ADDENDUM

ADDENDUM NO.: 03
PROJECT NAME: CDOT – Lincoln Square Brown Line Area Improvements
PROJECT NO.: 22705
CONTRACT NO.: C1612
DATE OF ISSUE: August 15, 2024

NOTICE OF CHANGES, MODIFICATIONS, OR CLARIFICATIONS TO CONTRACT DOCUMENTS

DRAWING NO. **L-3**
 SHEET NO. **A-17**

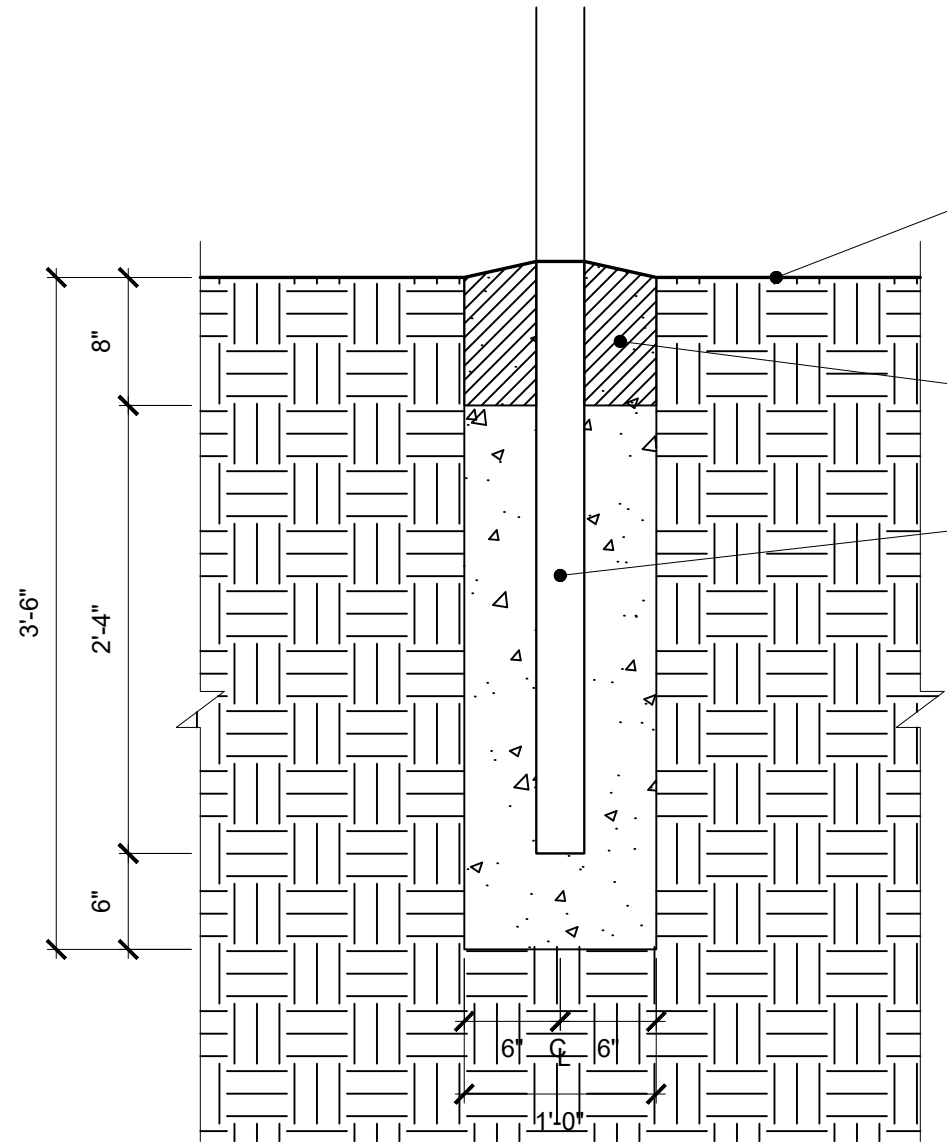
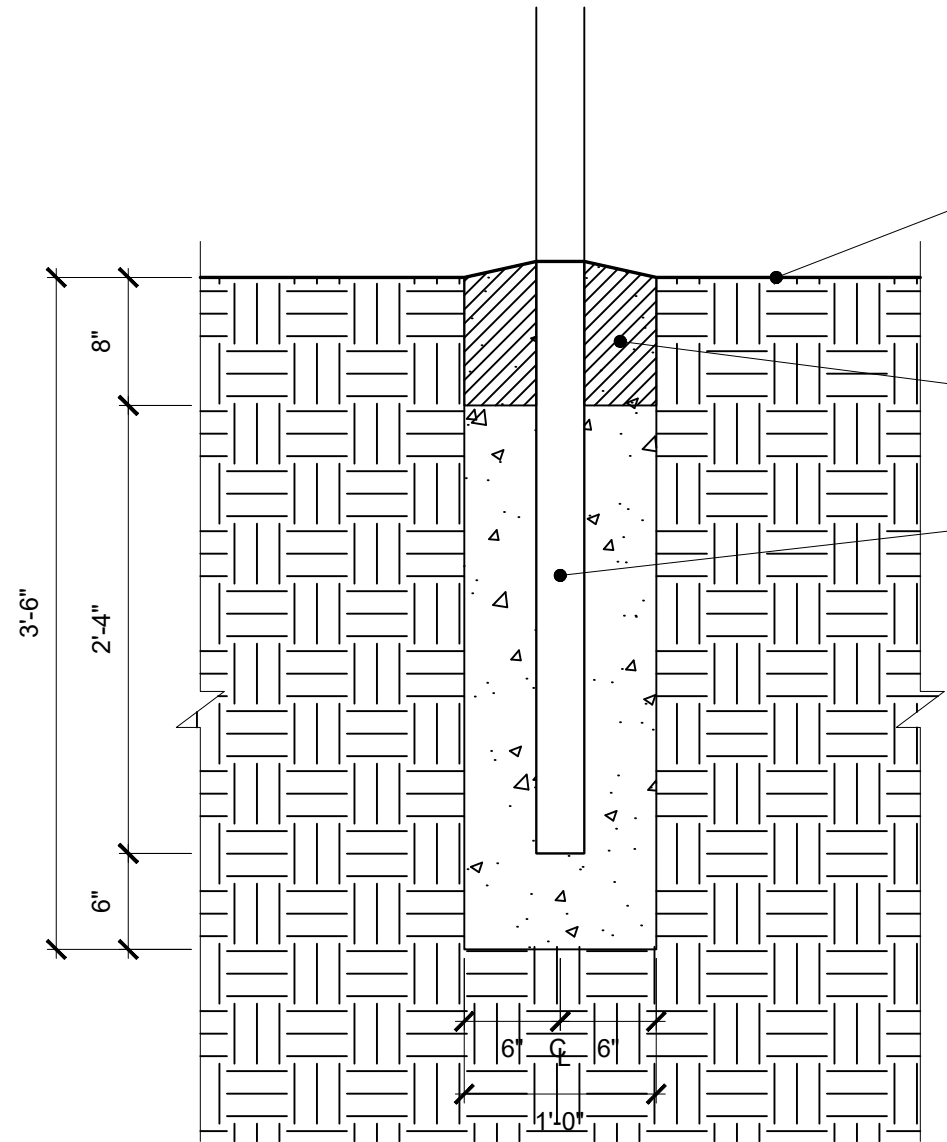
- Change 21 REVISED** Drawing No. SF-21, revisions to the identifier details
Change 22 REVISED Drawing No. SF-22, revisions to the identifier details
Change 23 REVISED Drawing No. L-3 (Sheet A-17), revisions to the fencing detail and foundation section
Change 24 REVISED Drawing No. L-3 (Sheet B-19), revisions to the fencing detail and foundation section
